HISTORIC AND DESIGN REVIEW COMMISSION

June 16, 2021

HDRC CASE NO: 2021-266
COMMON NAME: 613 N FLORES ST
LEGAL DESCRIPTION: NCB 132 LOT 38 FOX TECH HIGH SCHOOL
ZONING: D,RIO-7A
CITY COUNCIL DIST.: 1
LANDMARK: Individual Landmark
APPLICANT: Elizabeth Hurd/RVK Architecture
OWNER: Kedrick Wright/SAN ANTONIO ISD
TYPE OF WORK: Installation of a temporary parking lot
APPLICATION RECEIVED: May 26, 2021
60-DAY REVIEW: Not applicable due to City Council Emergency Orders
CASE MANAGER: Stephanie Phillips
REQUEST:

The applicant is requesting a Certificate of Appropriateness for approval to install a temporary surface parking lot at the lot addressed 613 N Flores.

1 SITE PLAN

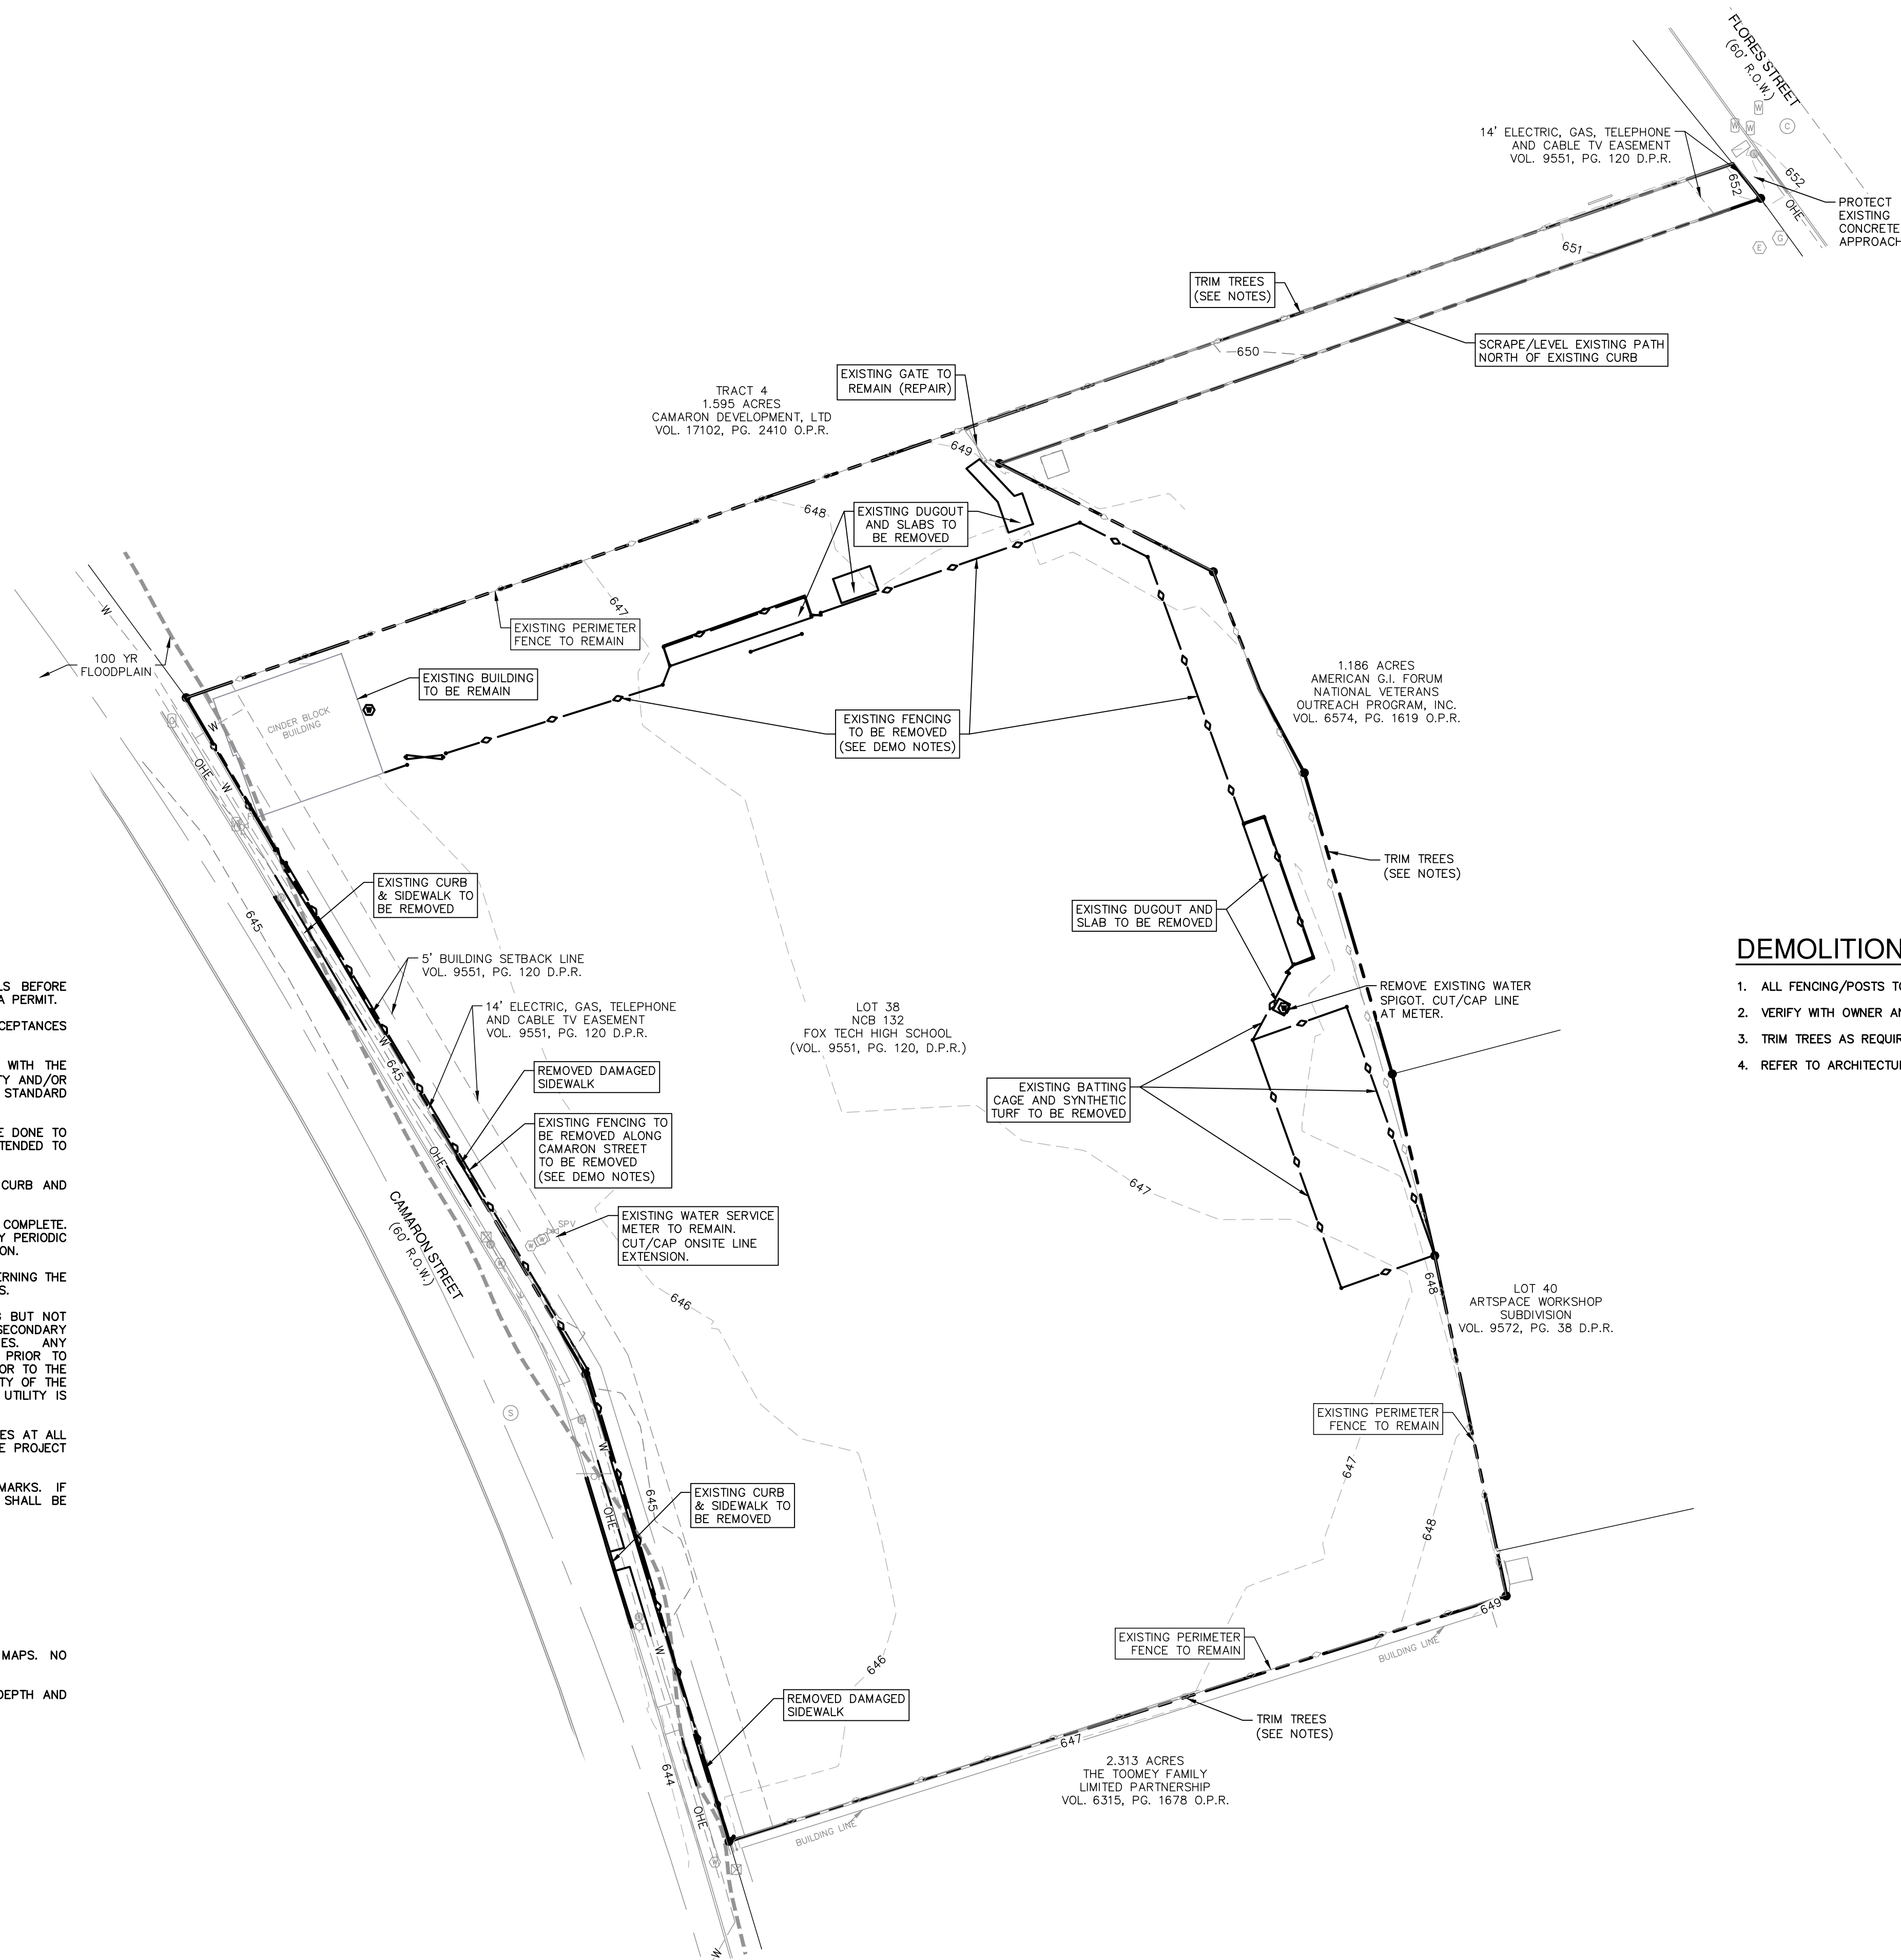
- b. **PARKING AND HARDSCAPING** – The lot will feature parking for approximately 220 cars and will be installed through December 2024 to serve the Fox Tech Campus and overflow for the Central Office Building. As noted in finding a, the east side of the lot fronts San Pedro Creek. Based on the submitted site plan, the lot will span the entire Camaron street frontage, which is a two lane automobile street. According to UDC Section 35-672, large expanses of surface parking lots have a negative impact on street activity and the pedestrian experience. Parking lots should be avoided as a primary land use, and permanent parking lots as a primary use are prohibited in RIO-3 and RIO-7 for all properties that fall within one hundred (100) feet of the river or creek right-of-way in all RIO districts. The proposed parking lot is within one hundred (100) feet of the San Pedro Creek right-of-way. Staff finds that the proposed parking lot is permissible exclusively due to its temporary nature. Staff finds that the submitted site plan should be updated to include a substantial landscape buffer as required by RIO-7A standards and UDC requirements to ensure the parking lot is properly screened from the right-of-way and San Pedro Creek.

- ii. That the applicant update the submitted site plan to include a substantial landscape buffer as required by RIO-7A standards and UDC requirements to ensure the parking lot is properly screened from the right-of-way and San Pedro Creek. The site plan is required prior to the issuance of a Certificate of Appropriateness or approval of a permit.
